VOLUME 2 OF 2 - ZONING

AAJ
217 WEST 10TH STREET
NEW YORK, NY

Z-003.00

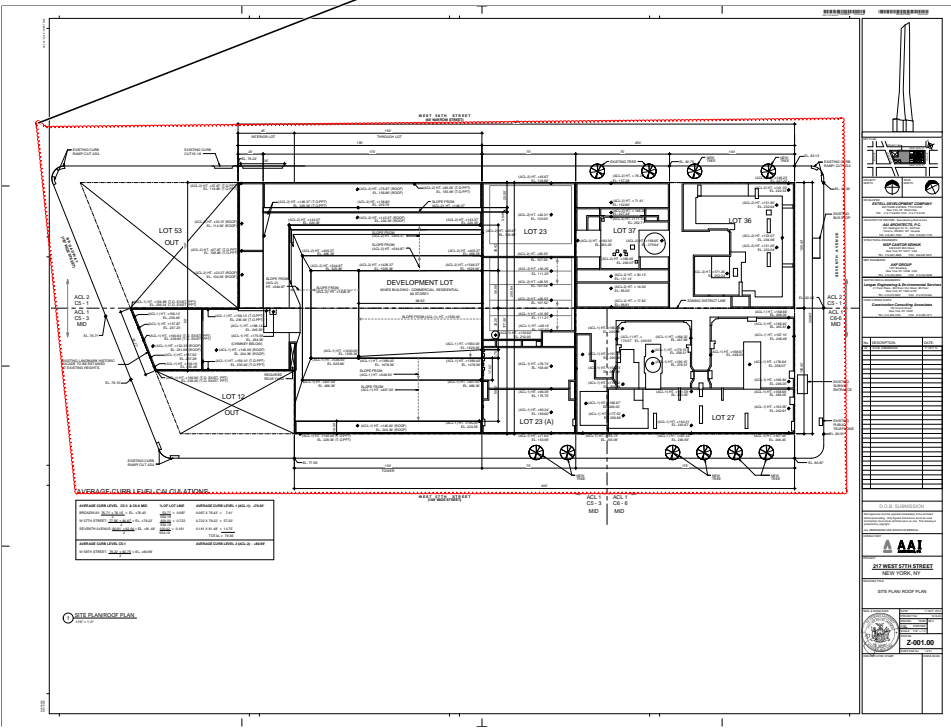
Verify compliance with street tree planting for the entire zoning lot street frontage as per ZR 33-03. Provide ST-1

Author: dtitus Subject: Polygon Date: 1/7/2013 9:09:57 AM
Area indicated is for residential use only with a sq. footage of 1,505.
Fifteen square feet is required per bicycle parking space; commissioner approval is required if submission of a more efficient layout is provided.
(Please indicate in Schedule "A" square-footage with total bicycle parking provided)

Author: dtitus Subject: Polygon Date: 1/4/2013 10:59:34 AM
Provide application for low income housing. 104166466 11-13-13

Provide HPD letter. Indicate compliance with inclusionary floor area calculations on zoning floor area schedule to identify compliance with HPD inclusionary housing letter.

Provide records to verify proof of existing conditions shown on plans provided, approved drawings of existing building floor area zoning calculation to ensure that the proposed zoning analysis does not exceed the maximum permitted

Verification of existing mechanical deductions is required. Sufficient proof must be provided for entire the deducted floor area. (Dimensions) and provide layout of heavy equipment for each floor in consideration to qualify for deductions.

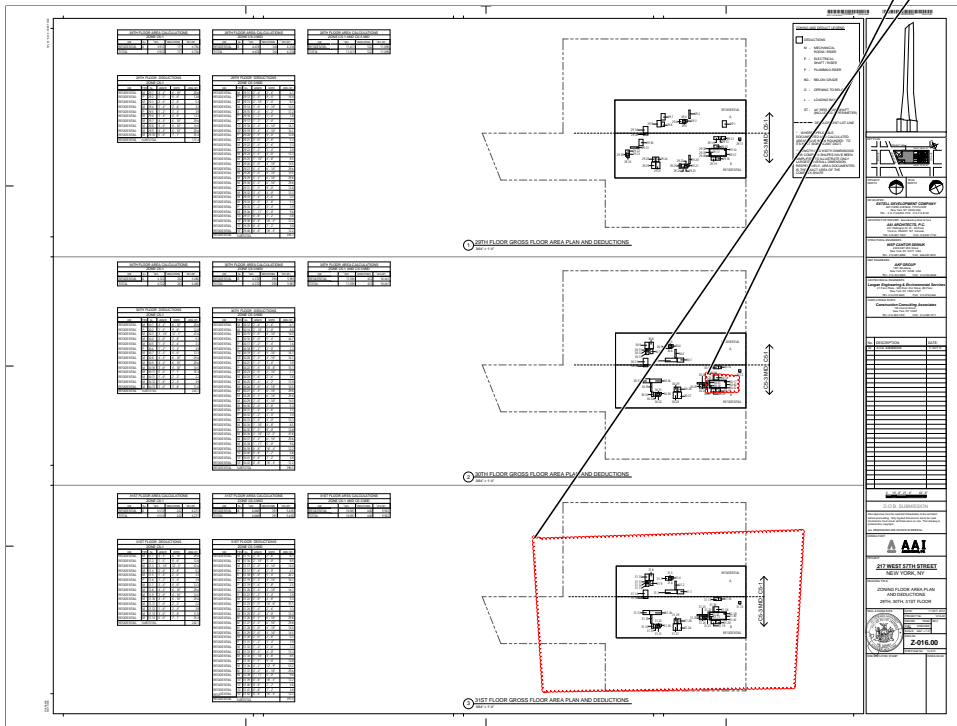
Please clarify deductions taken within stair inclosure. **TYP all floors**
8" for the stair perimeter, not sure what the additional 60+ sq. ft. is for per floor. ARCH/MH dwgs does not indicate any shaft enclosures within stair.

Mech. plan was not provided for this floor. 31st FL.

was not provided for this floor. 32nd FL.

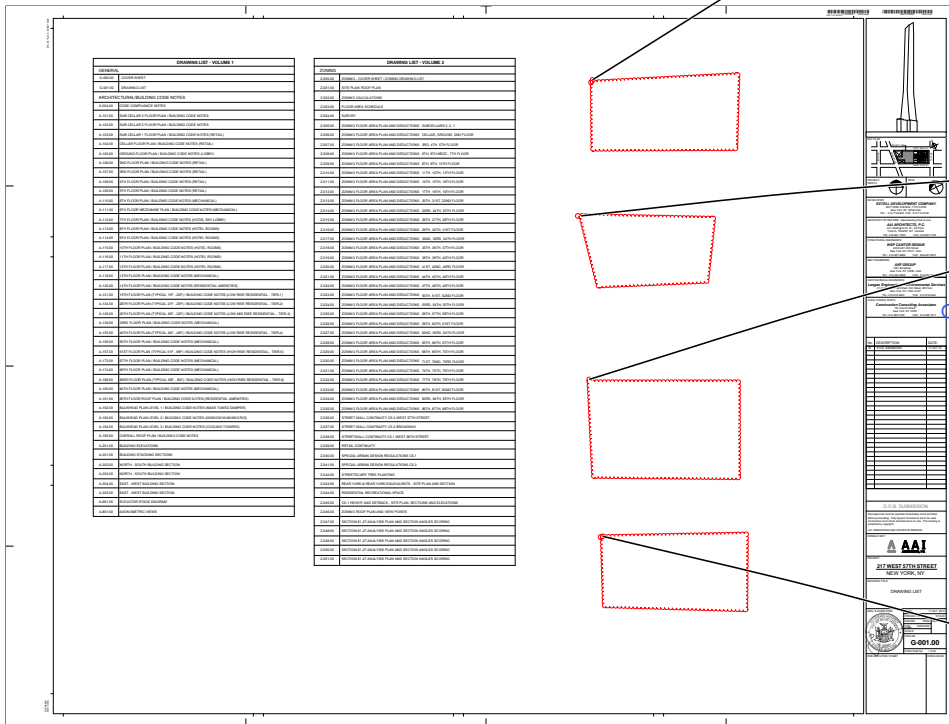
NYC ENERGY CODE 2011
BC 1301 Provide data sheet and state on plans, full compliance with NYC energy code.

List all progress inspections for energy code compliance on drawing.

Supporting documentation: building wall sections fail to detail insulation as continuous and/or cavity insulation to match the location and R value in the energy analysis.

Supporting documentation: door, window and skylight schedules fail to provide columns for u values for each exterior door, window and skylight type. If door, window and skylight types are drawn instead, with specifications included next to the respective drawing, u and SHGC values must appear with the other performance specifications for clarity and ease of contractor take-offs.

Supporting documentation: heating and cooling systems, including controls, are not provided such that they match the systems, equipment and performance criteria in the energy analysis.

Supporting documentation: plans fail to include reflected ceiling plans or lighting layouts on floor plans with fixture types and quantities, lamp wattages and quantities, space areas, sensors and controls to match those in the energy analysis for each room in the building.

Supporting Documentation: Building wall sections fail to label insulation at the roof/ceiling, wall and/or at the foundation, slab-on grade, basement or cellar with R values matching those in the Energy Analysis.

Indicate on drawings fire ratings for all proposed partitions /interior sections and details for verification purposes construction. Indicate construction materials and fire rating of construction elements of building to verify compliance with requirements of Table 601 class I-B structure. 03-09-15

BC 903.2.10 Trash compactor is required for building which contains more than 12 units.

Indicate trash compactor size, dimensions, & location.

- Indicate sprinkler locations in the trash compactor room.

- indicate ventilation to fresh air at trash compactor room

Indicate a minimum, 3 hr fire rated enclosure (walls) at trash compactor room i, including 1 1/2hr EPSC rated door.

- indicate construction details and materials at trash compactor room

Indicate sound transmission class (stc) ratings for all trash compactor walls and trash chute walls and disposal; room walls.

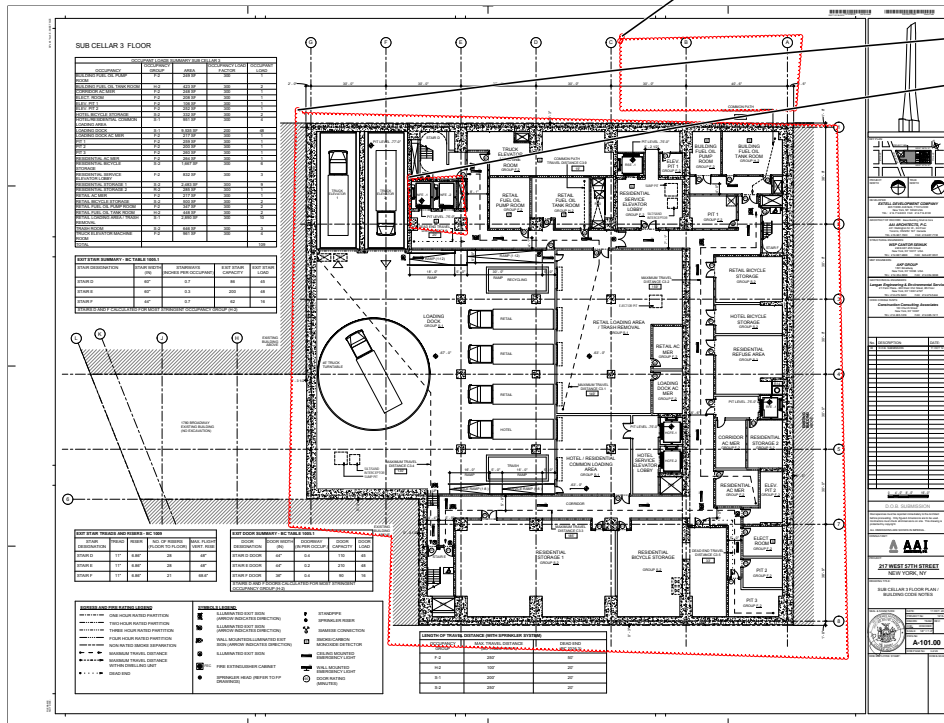
BC 405.4.3 Elevators. Verify compliance.

Author: dttus Subject: Polygon Date: 1/7/2013 10:15:09 AM
TABLE 403.1 Provide table for plumbing fixtures to comply with table 403.1. Provide calculations within each space, etc. and show layout to verify compliance to BC 1101.2; ICC/ANSI A117.1-2003

All nonresidential facilities to comply with BC 1109.

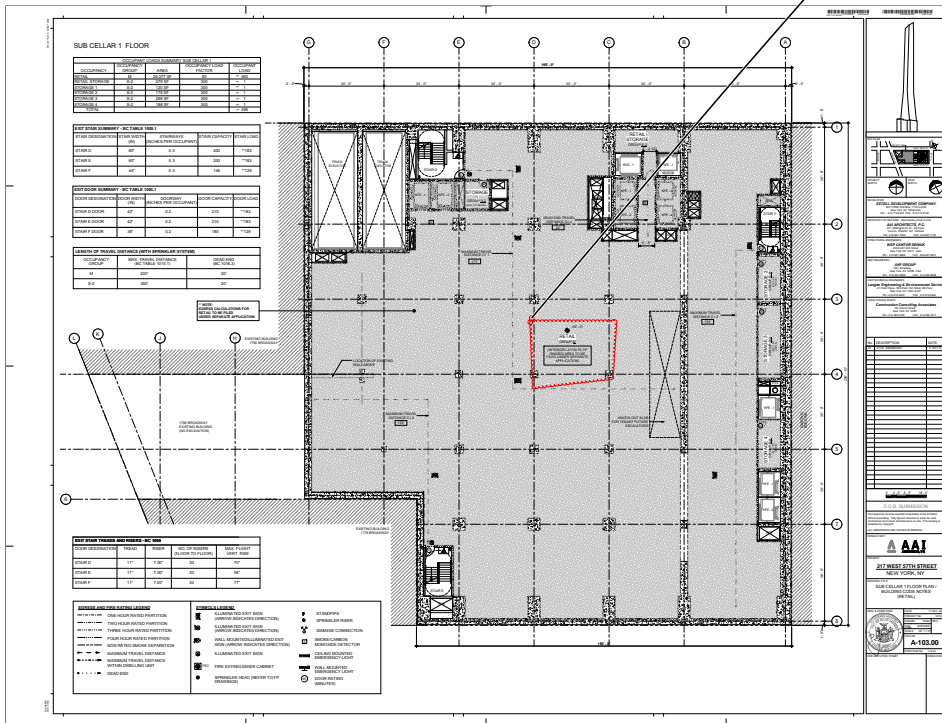
Water closets

Lavatories

Show all grab-bars including vertical

Required clearance around the water closet to comply with ICC/ANSI 2003 604.3

Author: dttus Subject: Polygon Date: 1/7/2013 10:14:55 AM
TABLE 403.1 Provide table for plumbing fixtures to comply with table 403.1. Provide calculations within each space, etc. and show layout to verify compliance to BC 1101.2; ICC/ANSI A117.1-2003

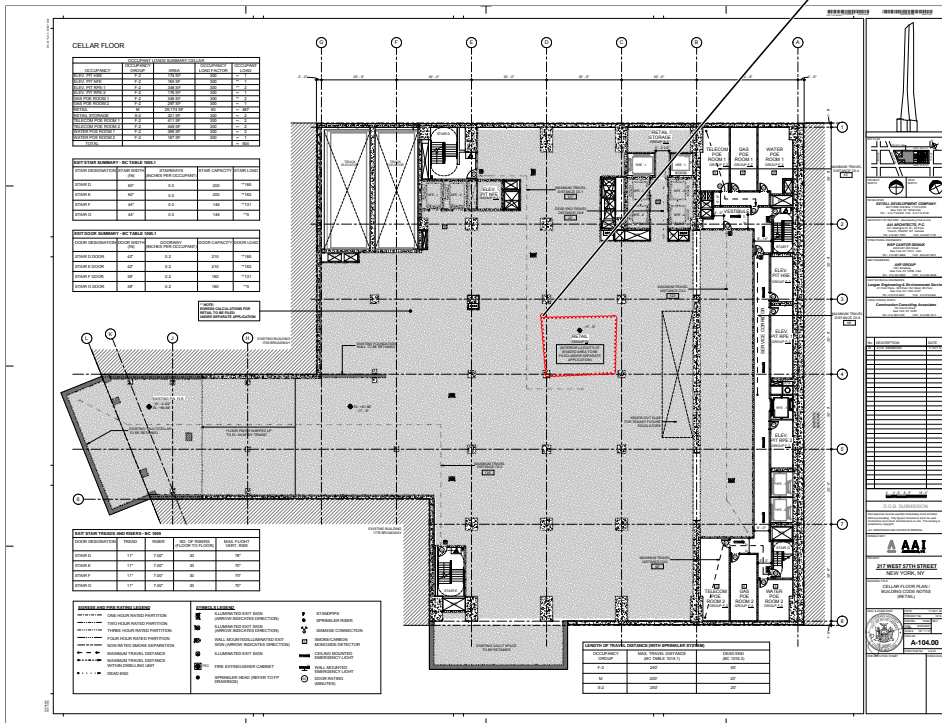
All nonresidential facilities to comply with BC 1109.

Water closets

Lavatories

Show all grab-bars including vertical

Required clearance around the water closet to comply with ICC/ANSI 2003 604.3

Author: dtitus Subject: Polygon Date: 1/2/2013 12:52:48 PM
Provide curb cut details with plans and sections. **Filed under sep appl: 04-03-13**

Location of proposed curb cut is contrary to section BC 406.7.6 (3). This is not a corner lot and a minimum separation of 8'-0" is required from side lot line.

Author: dtitus Subject: Polygon Date: 1/7/2013 10:14:43 AM
TABLE 403.1 Provide table for plumbing fixtures to comply with table 403.1. Provide calculations within each space, etc. and show layout to verify compliance to BC 1101.2; ICC/ANSI A117.1-2003 **03-09-15**

All nonresidential facilities to comply with BC 1109.
Water closets
Lavatories
Show all grab-bars including vertical
Required clearance around the water closet to comply with ICC/ANSI 2003 604.3 **04-03-13**

Author: dtitus Subject: Polygon Date: 1/2/2013 12:56:20 PM
Provide note to verify compliance with BC 1008.4.2, 1008.4.3, 1008.4.4 **04-16-13**

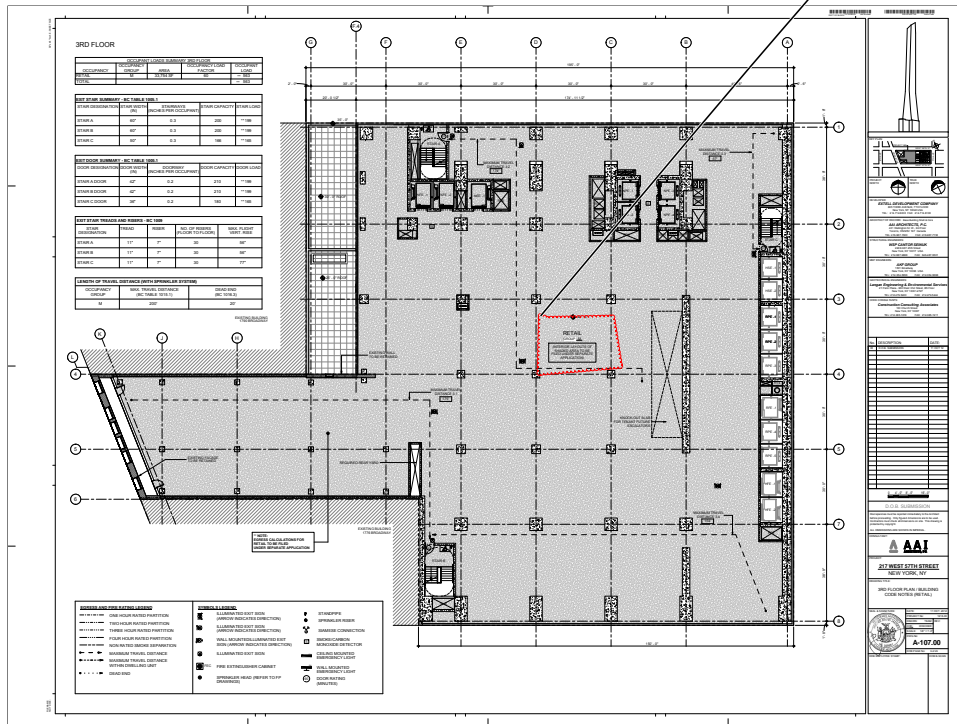
Water closets

Lavatories

Show all grab-bars including vertical

Required clearance around the water closet to comply with ICC/ANSI 2003 604.3

TABLE 403.1 Provide table for plumbing fixtures to comply with table. 403.1. Provide calculations within each space, etc. and show layout to verify compliance to BC 1101.2; ICC/ANSI A117.1-2003

All nonresidential facilities to comply with BC 1109.

Water closets

Lavatories

Show all grab-bars including vertical

Required clearance around the water closet to comply with ICC/ANSI 2003 604.3

Provide exit lighting and directional signs (lighting) & (egress) as per BC 1006, BC 1011, BC 1026 (both EG and Construction plans)

BC 903.2.12.2 Commercial cooking operations. An automatic sprinkler system shall not be installed in a commercial kitchen exhaust hood and duct system. Fire extinguishing systems shall be installed in commercial cooking systems in accordance with Section 904.11.

BC 904.2.1 Hood system suppression. Each required commercial kitchen exhaust hood and duct system required by the *New York City Fire Code* or the *New York City Mechanical Code* to have a Type I hood shall be protected with an approved automatic fire-extinguishing system installed in accordance with this code.

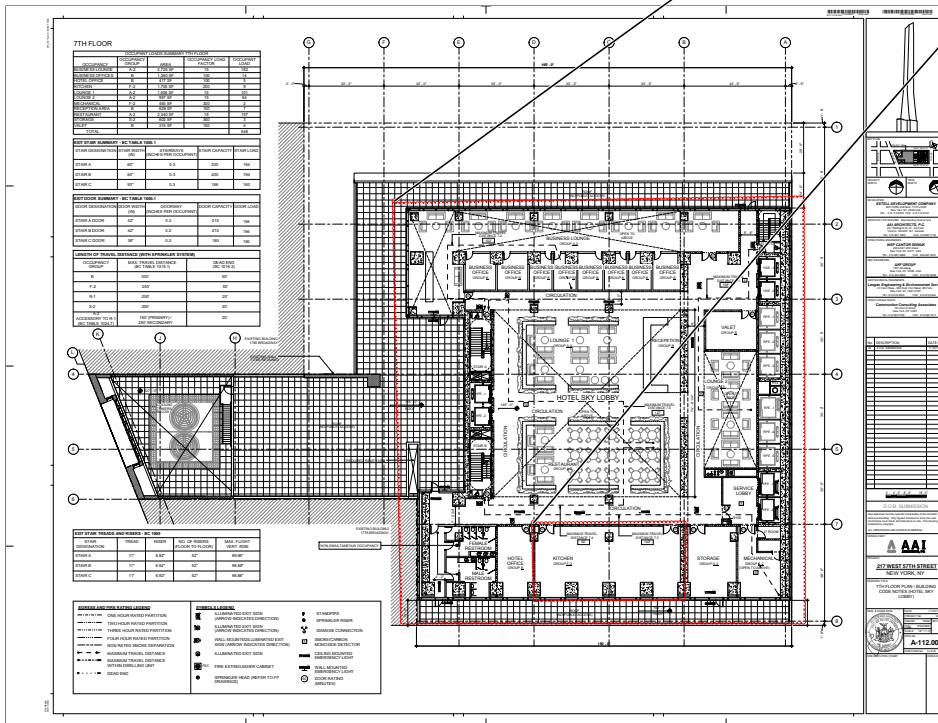
Kitchen shall also comply with MC 506, 507, and 508; PC 802.1.7 and 1003.3.1. Please verify on MH/PL plans.

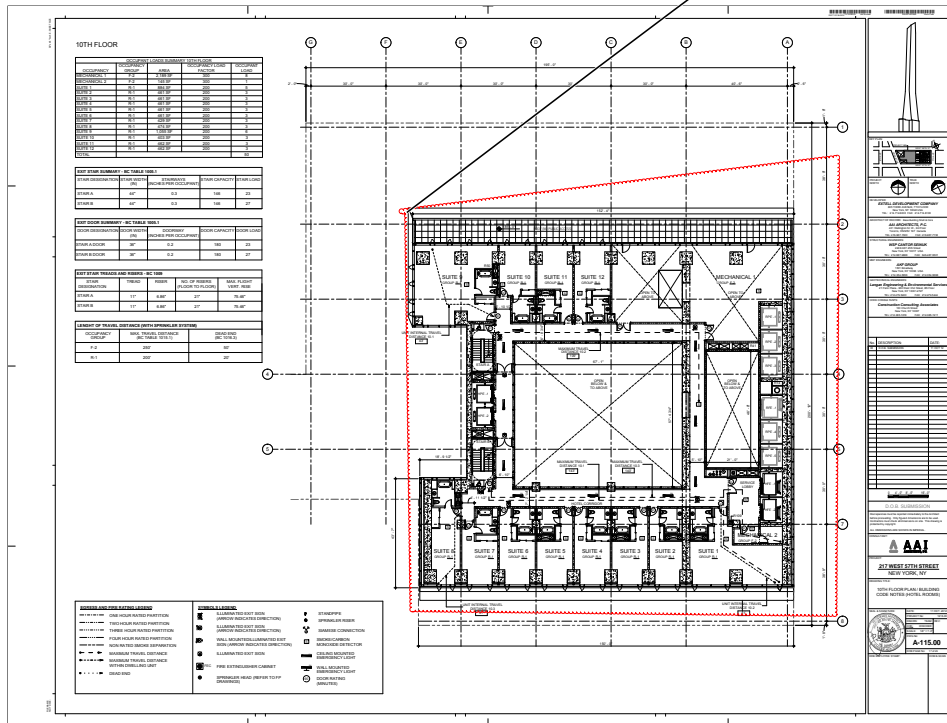
- Provide note describing stairway door operation and stairway communications system as per BC 403.12 04-16-13
- Provide note describing smoke proof exit enclosures for compliance with BC 403.13. 04-16-13
- Provide note describing impact-resistant stairs enclosures as per BC 403.15 04-16-13
- Indicate photo luminescent exit path markings as per BC 403.16. 04-16-13
- Provide exit lighting and directional signs (lighting) & (egress) as per BC 1006, BC 1011, BC 1028 (both EG and Construction plans) 04-16-13

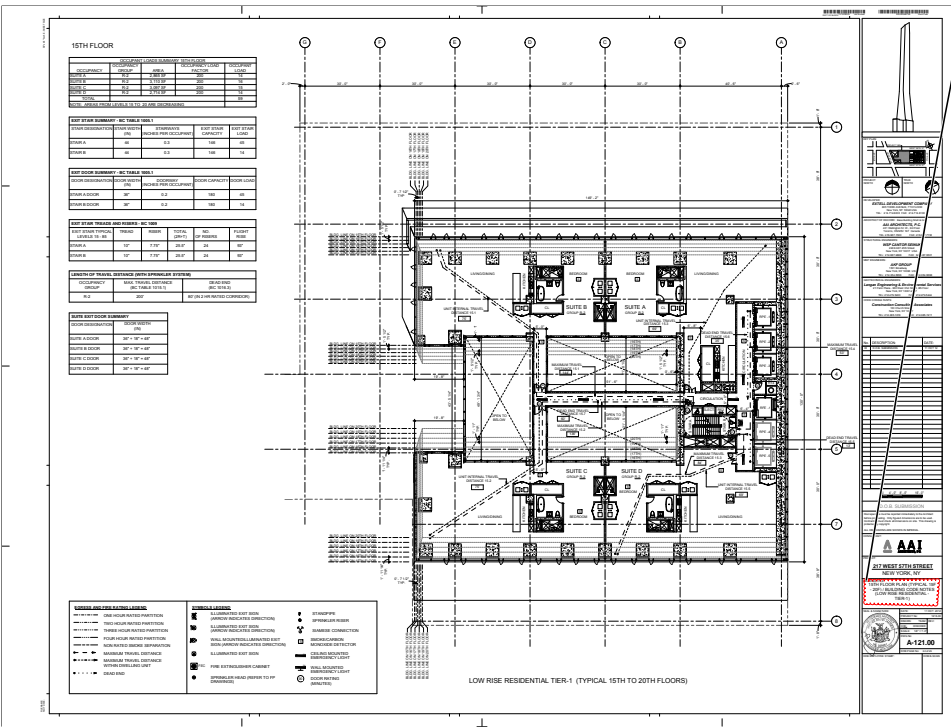
- Group R-1 occupancies shall be provided with accessible features in accordance with Sections 1107.6.1.1 through 1107.6.1.3.
- Show all grab-bars including vertical as per P102.8.3.1, (TYP) removed all R-1 04-13-15
- Provide note within each accessible unit: unit or sleeping unit shall comply with the 2008 code and Chapter 1 through Chapter 10 of ICC A117.1. (TYP) 04-16-13

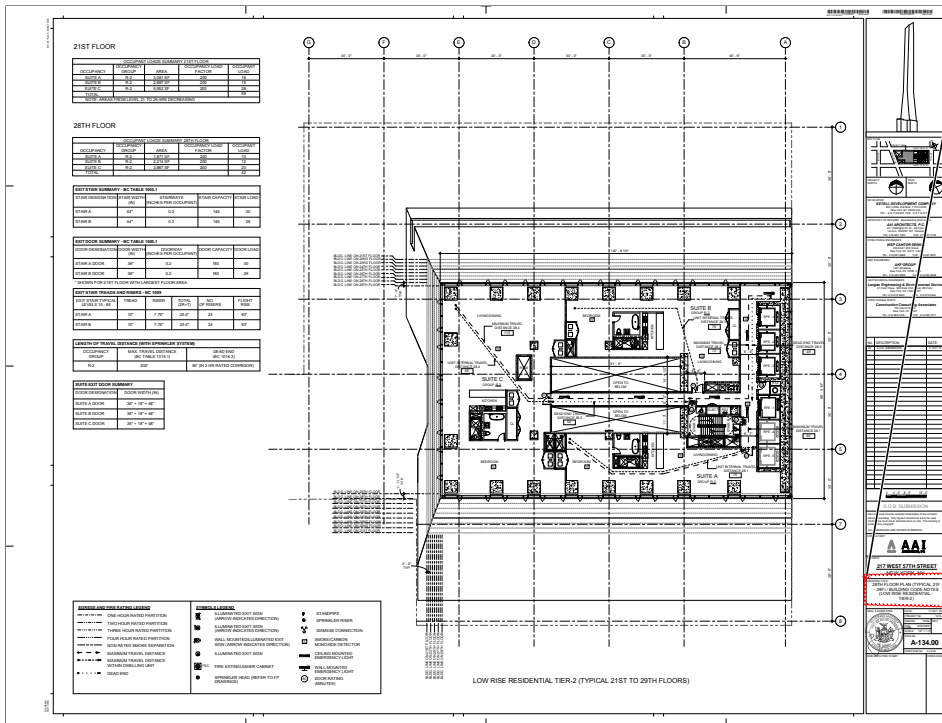
The common path of egress travel shall not exceed 125 feet as per BC 1013.3. The maximum length of exit access travel, measured from the most remote point within a story/space to the entrance to an exit along the natural and unobstructed path of egress travel, shall not exceed the distances given in BC Table 1015.1.

BC 908.7.1.2 Provide notes to indicate compliance for carbon monoxide detectors.

Indicate location of smoke/ carbon monoxide detectors. (TYP.)

Provide refuse chute details: [2 hr fr walls & roof] and compliance with BC 1213.3 and BC 707.13

Refuse storage room to comply with BC 1213.1

Provide proper enclosure and details

Provide UL # for system or fire hopper doors

Compliance with BC 1101.2;

Provide note describing stairway door operation and stairway communications system as per BC 403.12

Provide note describing smoke proof exit enclosures for compliance with BC 403.13.

Provide note describing impact-resistant stairs enclosures as per BC 403.15

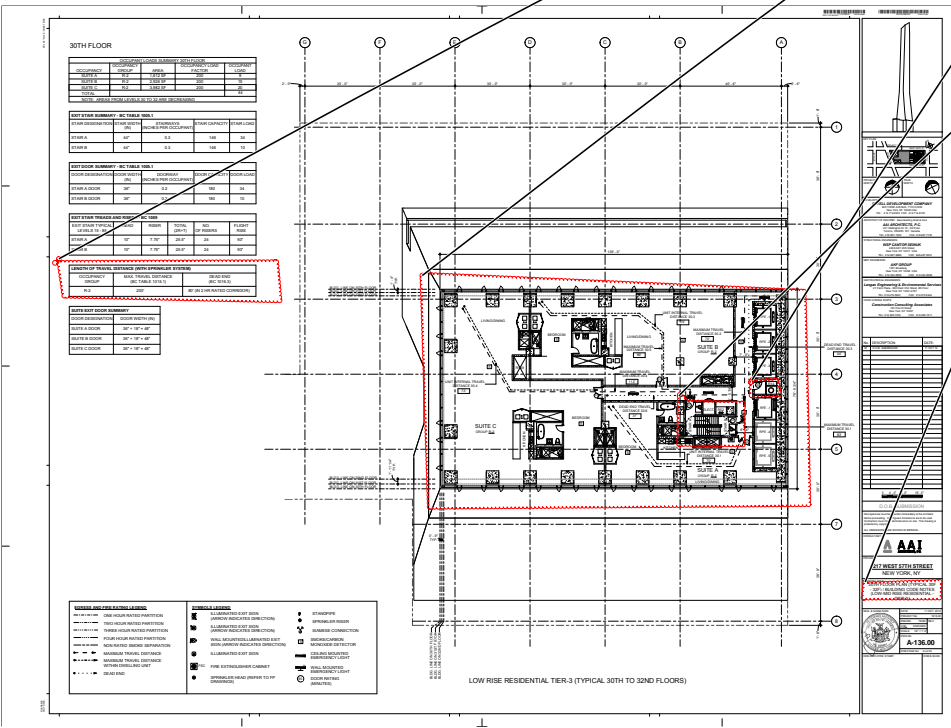
Provide exit lighting and directional signs (lighting) & (egress) as per BC 1006, BC 1011, BC 1026 (both EG and Construction plans)

Please indicate as Typ. 30-32nd Floor Plans
